Access Compliance Report

Public Rights-of-Way

Intersection ID: 12493	Main Street: BELVEDERE_AV	Cross Street: WINTER_ST	Location: SE
ADA ID: 380225964CAF	Ramp Type: BlendTrans1	Initial Pass/Fail: Fail	Overall Compliance: No
		Severity Score: 1.25

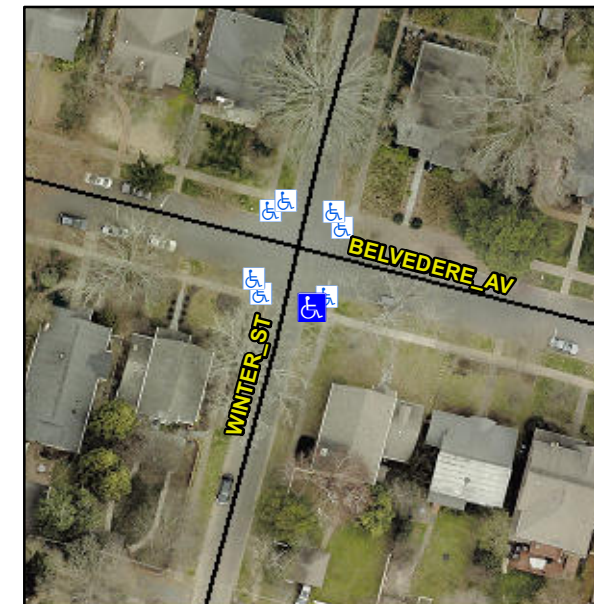
UTLITY POLE LT FL, FAILED INITIAL VALIDATION

R304.5.3

Compliance	Description	Data	Compliance	Description	Data
N/A	Ramp Length (in)	84.5	Yes	BlendTrans Slope (%)	0.9
Yes	Ramp Width (in)	52.0	No	BlendTrans XSlope (%)	2.5
N/A	Flare Type LT	N/A	N/A	Flare Type RT	N/A
N/A	Flare Slope LT (%)	N/A	N/A	Flare Slope RT (%)	N/A
N/A	Flare Traversable LT?	N/A	N/A	Flare Traversable RT?	N/A
N/A	Landing Length (in)	N/A	N/A	DWS Provided?	N/A
N/A	Landing Width (in)	N/A	N/A	DWS Contrast?	N/A
N/A	Landing Slope (%)	N/A	N/A	DWS Length (in)	N/A
N/A	Landing X Slope (%)	N/A	N/A	DWS Full Width?	N/A
N/A	Landing Curb? (Y/N)	N/A	N/A	DWS Offset (in)	N/A
N/A	Shared Landing?	N/A			
N/A	Gutter Ponding?	N/A	N/A	Gutter Slope (%)	N/A
N/A	Gutter Lip Ht (in)	N/A	N/A	Gutter X Slope (%)	N/A
N/A	Painted X Walk1?	No	N/A	Painted X Walk2?	N/A
	X Walk 1 Direction	To W		X Walk 2 Direction	N/A
	X Walk 1 Width (in)	N/A		X Walk 2 Width (in)	N/A
	X Walk 1 Slope (%)	4.4		X Walk 2 Slope (%)	N/A
	X Walk 1 X Slope (%)	1.0		X Walk 2 X Slope (%)	N/A

Remove & Replace Curb Ramp With Two New Directional Ramps or Equivalent.
